WEST SUSSEX COUNTY COUNCIL CONSULTATION

TO:	Mid Sussex District Council FAO: Steven King
FROM:	WSCC – Highway Authority
DATE:	27 January 2025
LOCATION:	Land East Of Lunce's Hill Fox Hill Haywards Heath West Sussex
SUBJECT:	DM/25/0827 Outline planning application for the erection of up to 130 dwellings, together with the change of use of an existing barn for a flexible community and/or commercial use, along with associated outdoor space and landscaping, drainage infrastructure, hard and soft landscaping, parking, access and associated works (all matters reserved except for access). Additional information and amended plans received 03/09/2025.
DATE OF SITE VISIT:	24 April 2025
RECOMMENDATION:	More Information Required

This is the **fourth** West Sussex County Council Highway comments in response to the above planning application seeking outline planning application for the erection of up to 130 dwellings, together with the change of use of an existing barn for a flexible community and/or commercial use, along with associated outdoor space and landscaping, drainage infrastructure, hard and soft landscaping, parking, access and associated works (all matters reserved except for access

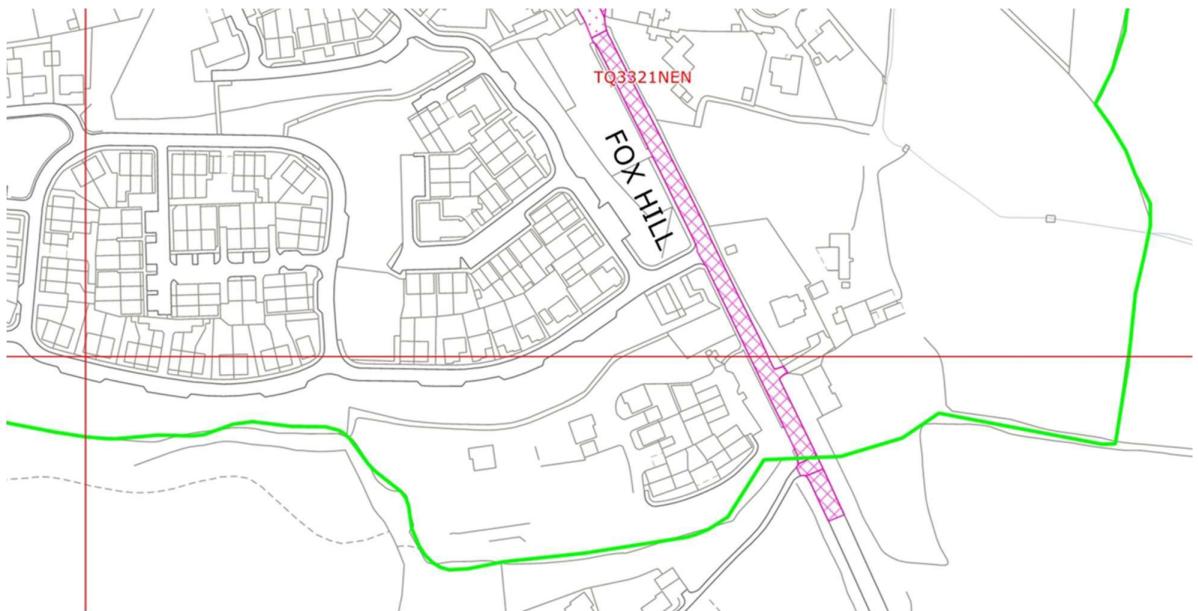
The extent proposed by the TRO is similar to that proposed in the additional site access drawing, along the B2112 to the south of the proposed site access bellmouth.

The extent of the TRO is shown in the screenshot below.

The current position is that WSCC has been asked to seal the WSCC TRO enacting a 30 MPH speed limit on Fox Hill, from its junction with Hurstwood Lane, southwards to the East Sussex County Boundary. The author has been advised that the Order went live on the 8 September 2025 with the new speed limit being fully installed on site in the last few weeks. However, at the time of writing, the positions of the new signs south of the site and in East Sussex are incorrect and will require alteration in the coming weeks. The Traffic Order requires them to be positioned on or immediately adjacent to the WSCC/ESCC border.

If the speed limit were to be extended across the border on highway within ESCC's jurisdiction, this will require ESCC to make a speed limit order on their side of the county boundary. WSCC has no legal jurisdiction to extend our Order onto their side of the boundary.

If ESCC make an Order for a 30 MPH Speed limit on their side of the County boundary, the speed limit terminal signs for the WSCC speed limit will be incorrect. Therefore, some kind of Agreement would be needed requiring the developer to review and adjust all of the speed limit signage between Hurstwood Lane and the start of their revised speed limit in East Sussex to ensure compliance with guidance on the spacing of repeaters etc.

Also, the drawings provided with the planning application make no mention of whether any new street lighting is to be installed on Fox Hill/Lunces Hill as part of these works. If it is, the new WSCC speed limit Order and new signage would be invalidated and a new TRO required. This is because Fox Hill is currently unlit between Hurstwood Lane and the ESCC county boundary, so a 30 MPH speed limit Order was made. Such an Order is not permitted on a street-lit road, so introducing street lighting would require a further review of the WSCC section of the road.

Given the presence of the crossing at the point the speed limit changes, WSCC recommends that the extent of the new 30mph speed limit be extended southwards to take-in both the crossing and access to the development AND that the street lighting along Lunc's Hill be extended too, up to and including the new access to highlight both it and the

Drawing No. 332611520-STN-HGN-XX-DR-C-0103 P02 – Site Access Drawing with Gateway Feature and Speed Reduction shows the 30mph speed limit extended slightly into East Sussex (approximately 30m from the south side of the proposed site access). Mention is made to extending the street lighting to encompass the access and the Technical Note says that this will be picked up at detailed design stage. The Stage 1 Road Safety Audit also makes reference to both the speed limit change and requirement for street lighting, the latter to be extended northwards as well to link up with existing street lighting.

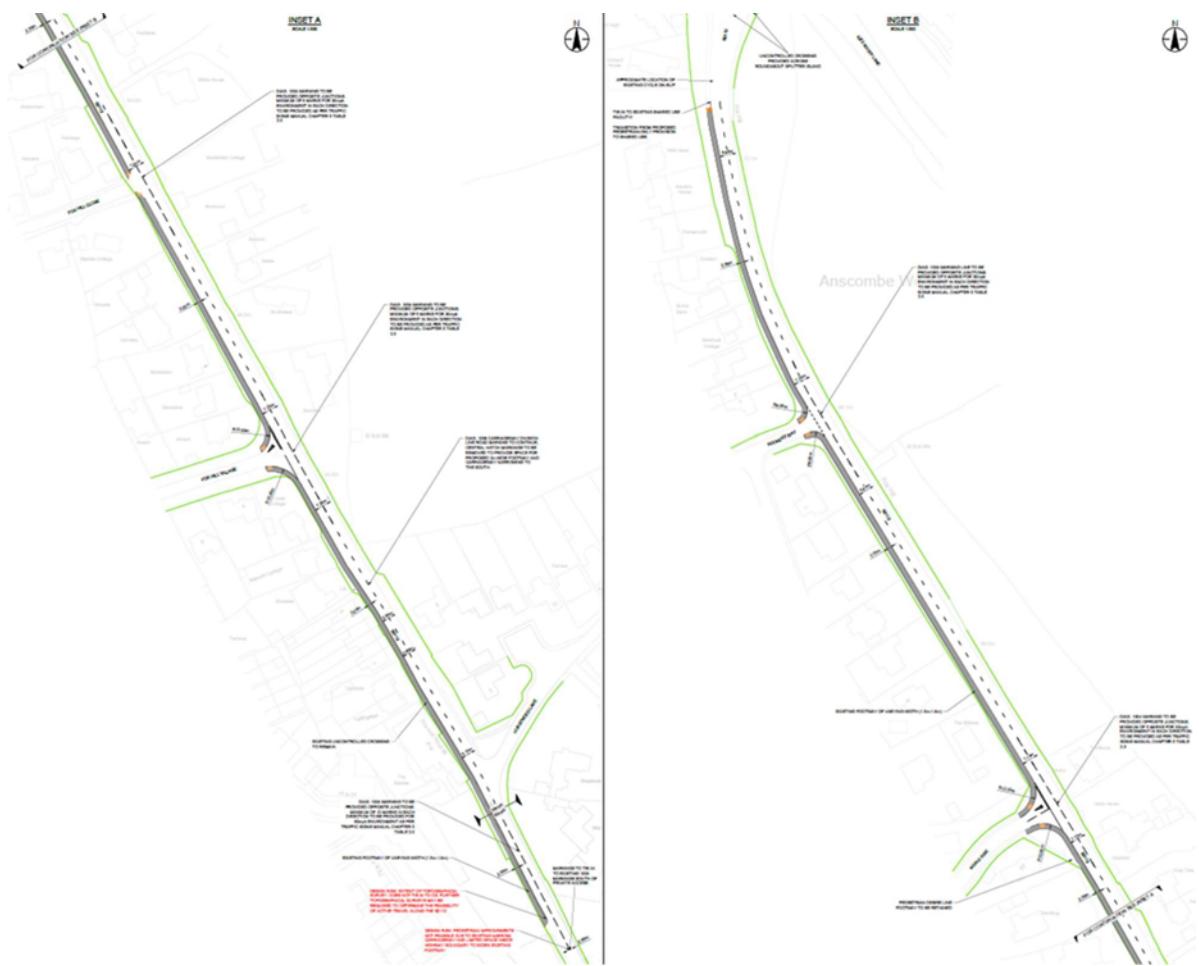
Stantec has undertaken a review of the existing provision along the B2112, focussing on the western verge where there is a greater opportunity for improvement. The review is focussed on widening the existing provision to a consistent width, as well as providing tactile paving at the crossings.

The extent of the proposed improvements are shown in the plan below, with the full plan provided in Appendix D.

The above is noted. **However, applicant to confirm whether these improvements are to be implemented as part of this planning application. If they are, then they should also be included in any Stage 1 Safety Audit Brief.**

The applicant has confirmed that these works are to be provided as part of the scheme. Lighting should also be extended northwards from the site access along this stretch to join up with any existing street lighting found further north.

The Preferred LCWIP Network for Hayward's Heath is shown in the screenshot overleaf:

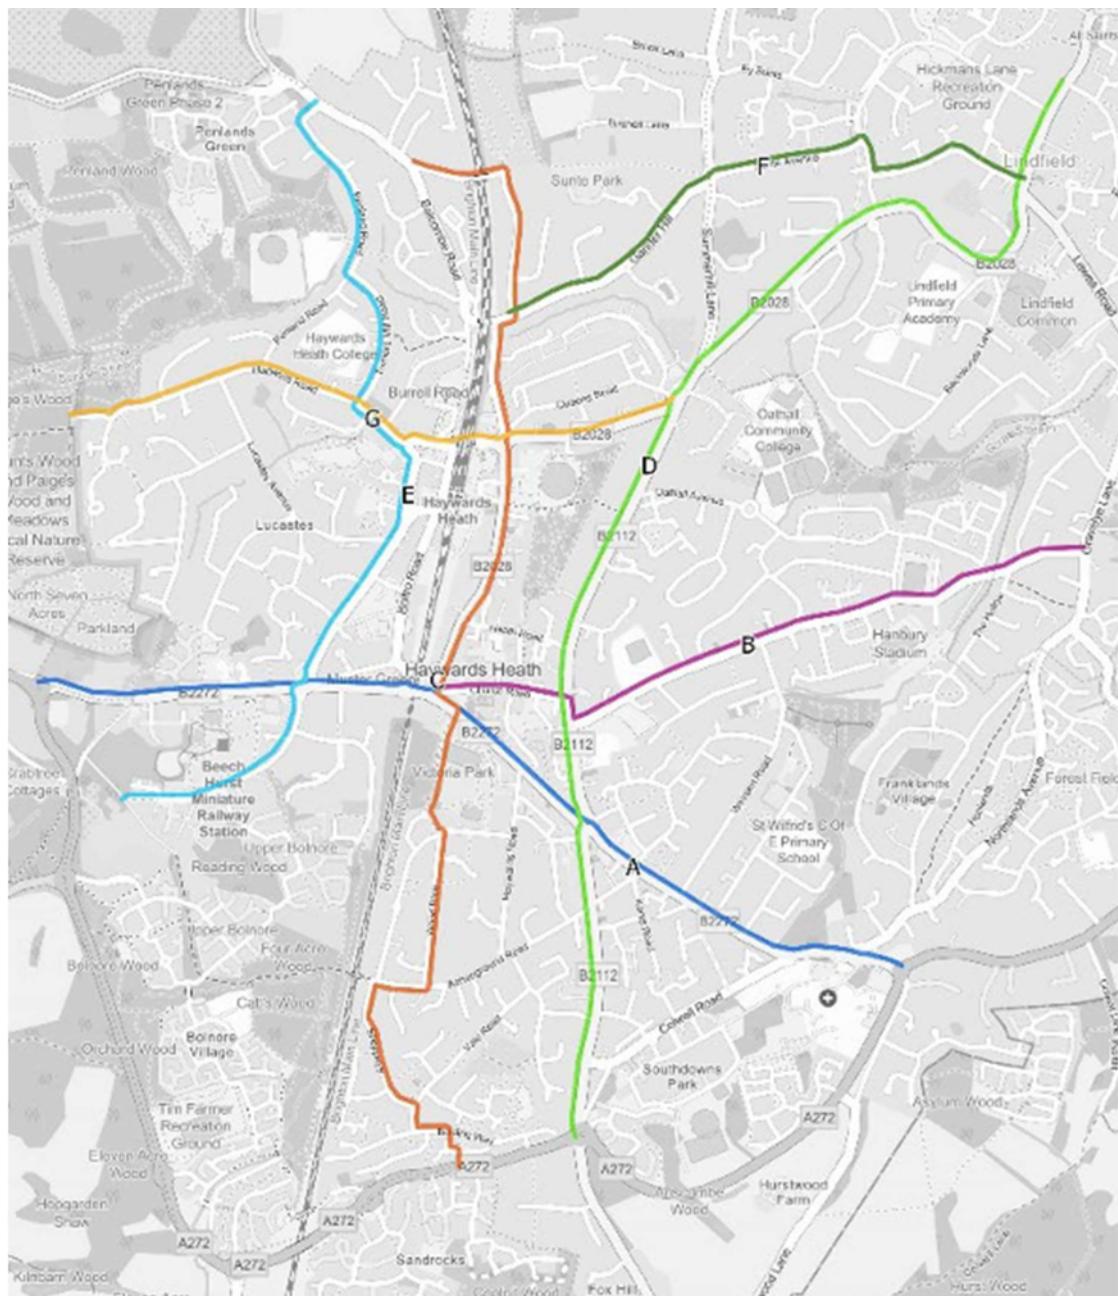
The Site would particularly benefit from improvements along Route D (light green) which provides a route for residents to the town centre from the roundabout with Lunce's Hill. It is recommended that further discussions are had with WSCC regarding potential proportionate financial contributions towards Route D.
